**BOULDER COUNTY
PLANNING COMMISSION
PUBLIC HEARING**

STAFF RECOMMENDATION

Docket SU-23-0005: Harvest Moon Solar Energy Facility

Request: Special Review to construct an approximately 10.3-acre Solar Energy facility on an approximately 35.5-acre parcel at 9770 Isabelle Road.

Figure 3. Proposed site plan submitted by the applicants.

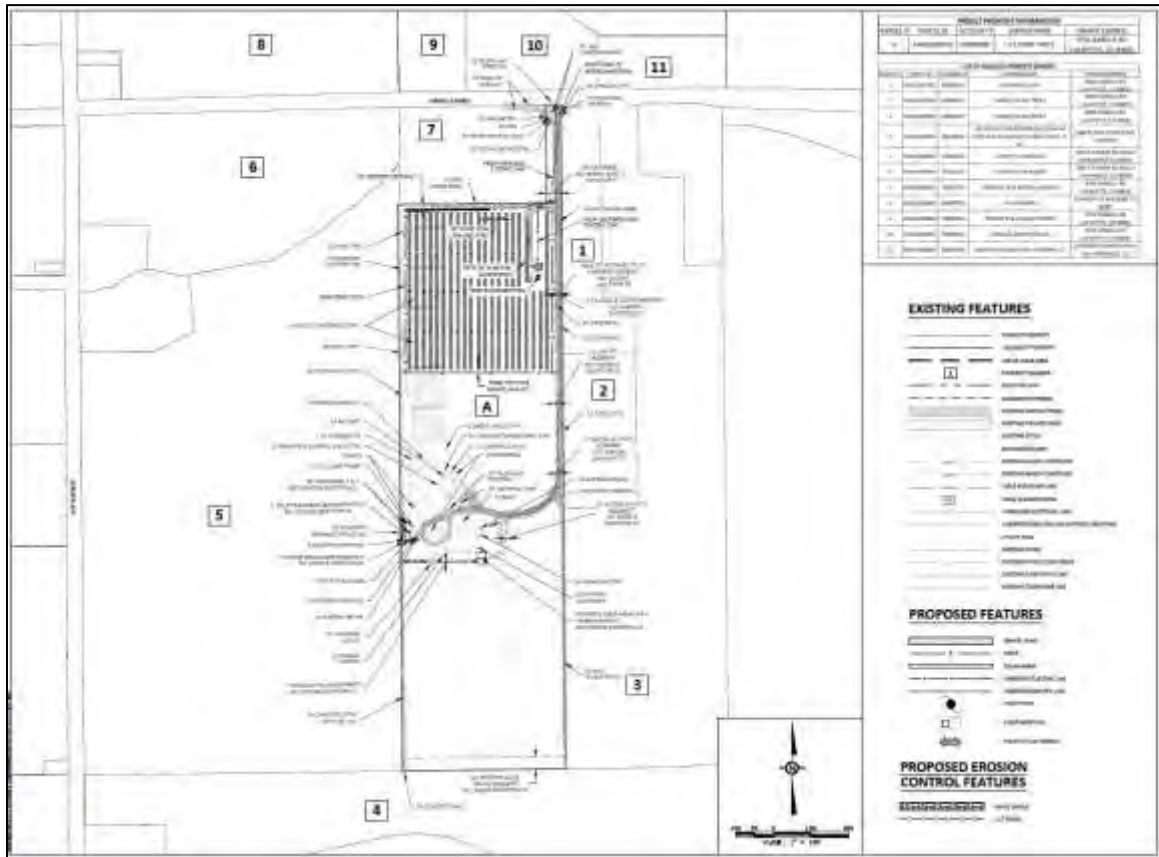
The proposed project area is immediately adjacent to multiple residential properties. There is a potential alternate location on the southern portion of the subject parcel, which would be farther removed from those residences (see Figure 3 above). However, based on staff's observations on-site and based on conversations with the property owner, the subject property slopes down on that southern portion of the parcel and that area is subject to flooding from an adjacent irrigation ditch. Staff finds that siting a solar energy facility in an area that is prone to flooding would not be appropriate. Additionally, locating the proposed solar energy facility on that southern portion would require significantly more grading and trenching. As such, staff finds the southern portion of the subject parcel would not be an appropriate location for the proposed solar energy facility. Additionally, as discussed in Criterion 9 below, staff finds that the impacts from the proposed solar facility on the adjacent residential properties can be mitigated through staff recommended conditions of approval.

Figure 9. Detail from proposed site plan, with section of fencing located in the required setback indicated in red.

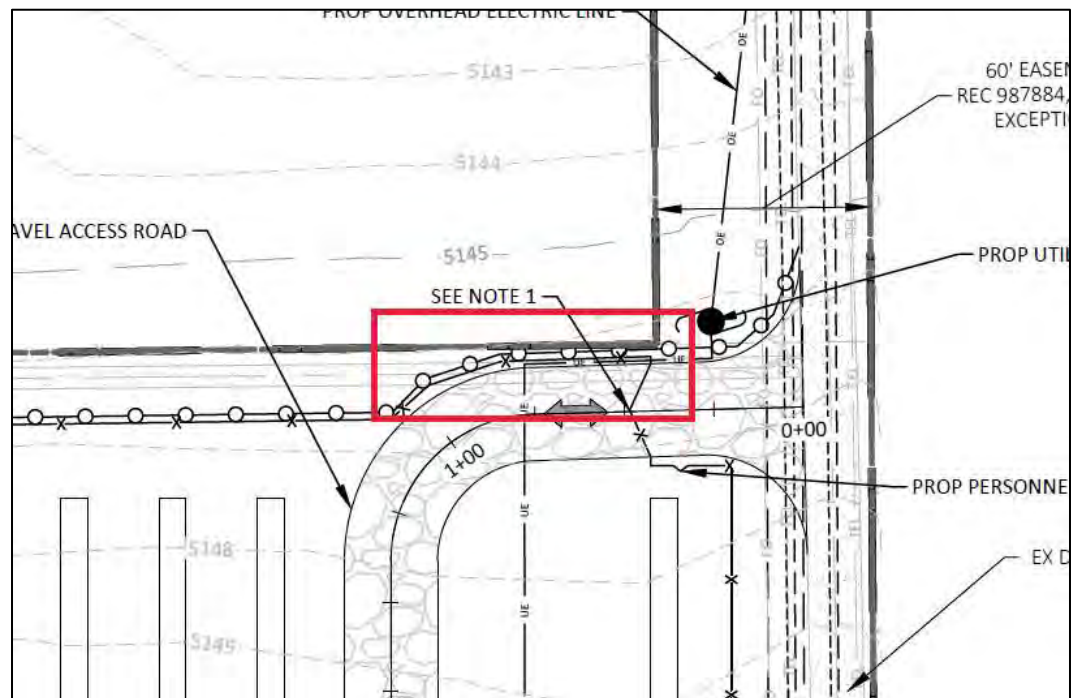
As discussed above, the proposed solar facility is allowed as an additional principal use on a parcel with existing principal uses. Staff has reviewed the proposed plans and has determined that the proposed development generally meets the required setbacks in the Agricultural Zoning District with the exception of the proposed fencing adjacent to the proposed access drive. The plans submitted with the application materials indicate the installation of a 7-foot fence around the system and associated equipment. Article 17-300.A.1.b of the Code allows the construction of a fence not over 6 feet high without a building permit. Conversely, fences more than 6 feet in height require a building permit and must meet setbacks. The applicable setback in the Agricultural Zoning District is 7 feet. The site plans as submitted show a section of fencing located approximately on the property line, within that setback (see Figure 9 below). Staff recommends conditions of approval requiring that a revised site plan be submitted showing that the fence meets the applicable setbacks for the Agricultural Zoning District and is issued a building permit, or the height of the proposed fence be reduced to no more than 6 feet in height within the required setback.

2. The maximum height of any given panel in the system is not to exceed 11 feet above existing grade.
3. Plans submitted for permitting must show that all fencing of more than 6 feet in height meets the applicable setbacks for the Agricultural Zoning District and is issued a building permit.

Figure 10. Aerial photograph of the area around the subject parcel (indicated in red, with the project area superimposed on it); nearby residences are indicated in yellow; existing line of trees on adjacent parcel indicated in green.

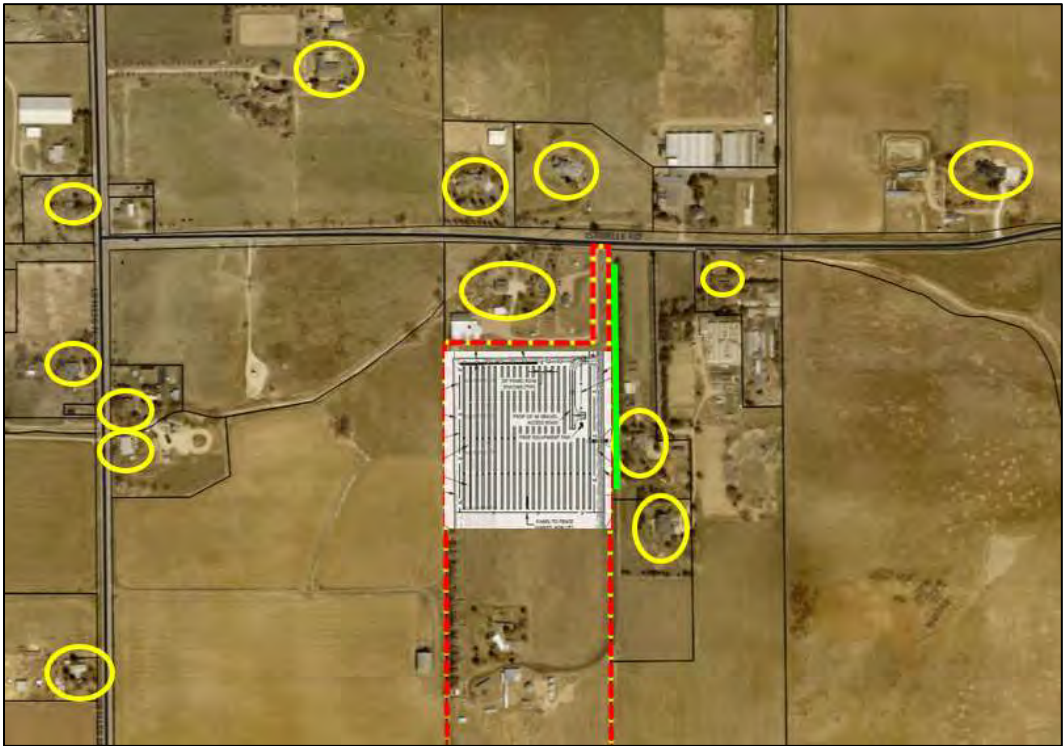
Per the application materials submitted, the applicants have proposed to install vegetative screening (juniper trees) along a portion of the northern project area (see Figure 6 above). This would help to screen the development from property immediately north of the project area. Based on observations on-site, however, staff finds that the proposed solar facility will have significant visual impacts on all of the adjacent properties to the east, north, and west. There are a number of properties with residences in the immediate vicinity of the project area (see Figure 10 below). Additionally, staff has determined that, due to the change in terrain, the development would also be highly visible from N. 95th Street, as N. 95th Street is downslope from project area (see Figures 11 and 12 below).

Given the proximity of these residences, the visibility from N. 95th Street, and the high visibility of the proposed solar facility, staff finds that that the project as proposed would result in significant negative visual impacts. There is an existing line of trees on one of the adjacent parcels to the east (indicated in green in Figure 10 below). However, it is staff's determination that relying on existing plantings on an adjacent parcel to screen development on the subject parcel effectively places the burden of mitigating the visual impacts of the development on the neighbor, rather than on the developer or applicants.

In order to reduce and mitigate the visual impacts of the proposed development, staff recommends as a condition of approval that the applicants extend the vegetative screening (the juniper trees as proposed in application materials) along all of the eastern, northern, and western edges of the project area, with the exception of the access drive to the project area (see Figure 13 below). This vegetative screening will help to shield the proposed panels and the proposed storage containers from adjacent properties and the public right-of-way, reducing and mitigating the visual impacts of the development.

To ensure that the vegetative screening is properly installed and maintained, staff recommends as a condition of approval that the applicants submit a detailed landscaping plan at permitting, showing the location of all landscape plantings, information on the specific species to be used, and watering and maintenance information. Additionally, staff recommends as a condition of approval that the applicants remove and replace any of the vegetative screening that dies or fails throughout the life span of the facility.

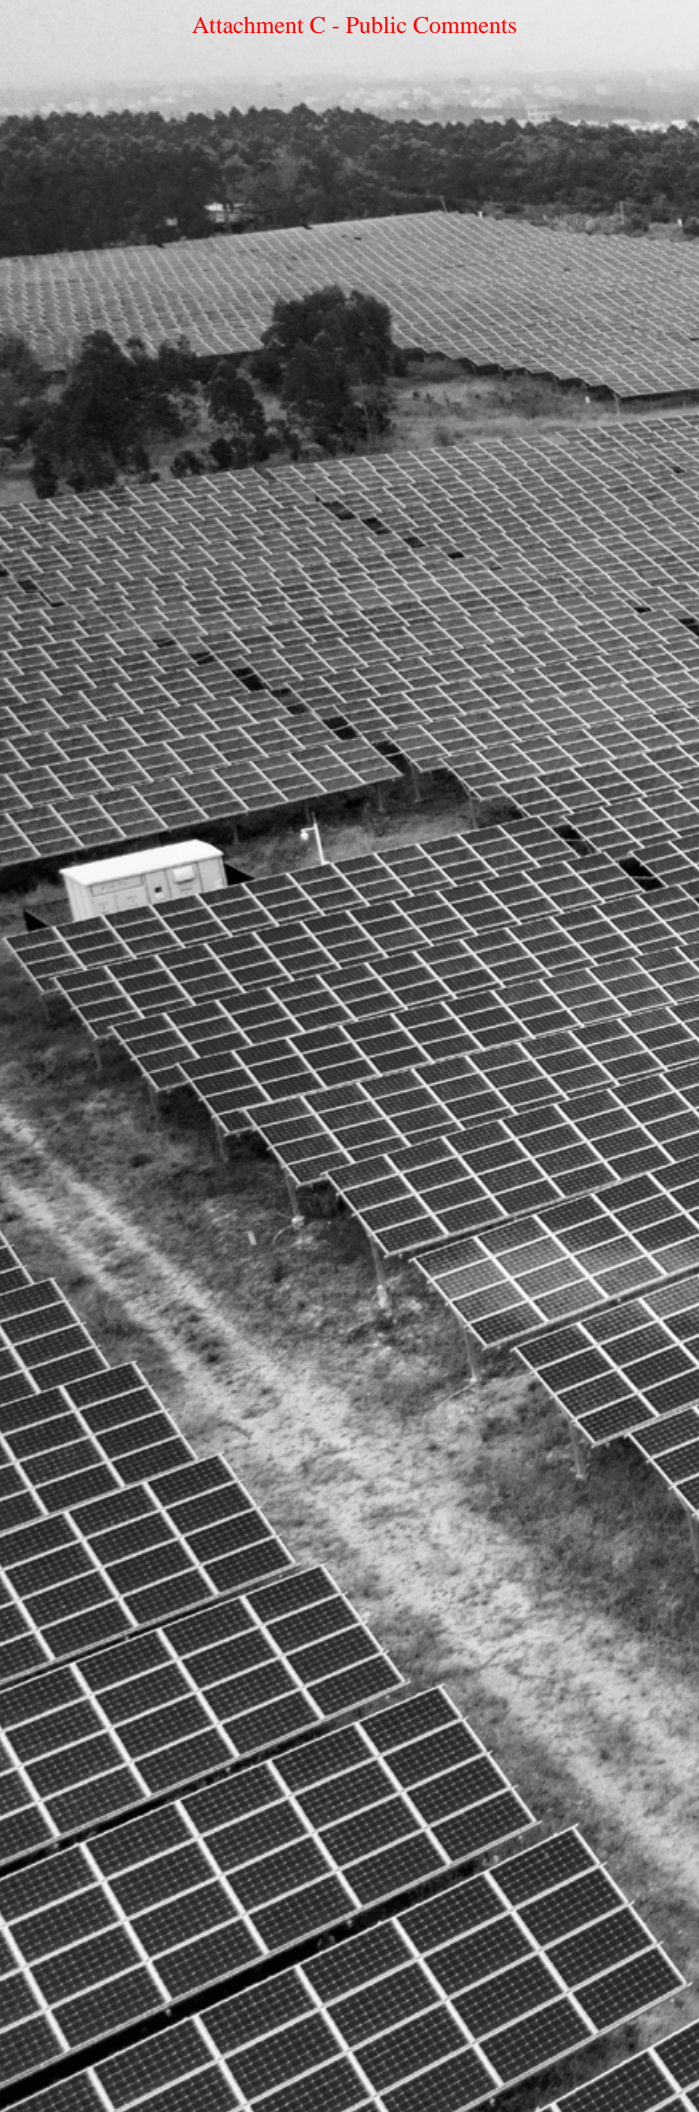
Figure 5. Proposed solar panel array plans submitted by the applicants.
